To: Planning Office Subject: POD2023-00422: Springhill Suites at  
Henrico County Police Division, Richmond Airport  
From: Community Services Unit Date: October 13, 2023

POD2023-00422

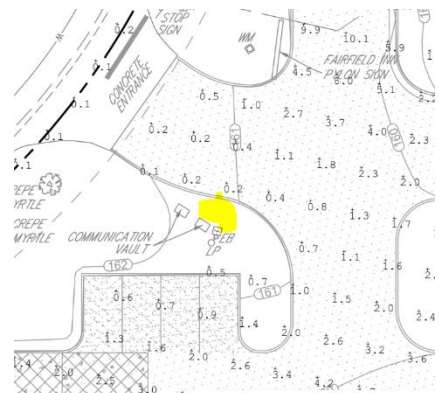
1. A sample CPTED Plan
2. A blank CPTED Plan checklist.
3. Consider adding a light fixture near the highlighted area Shown to the right.
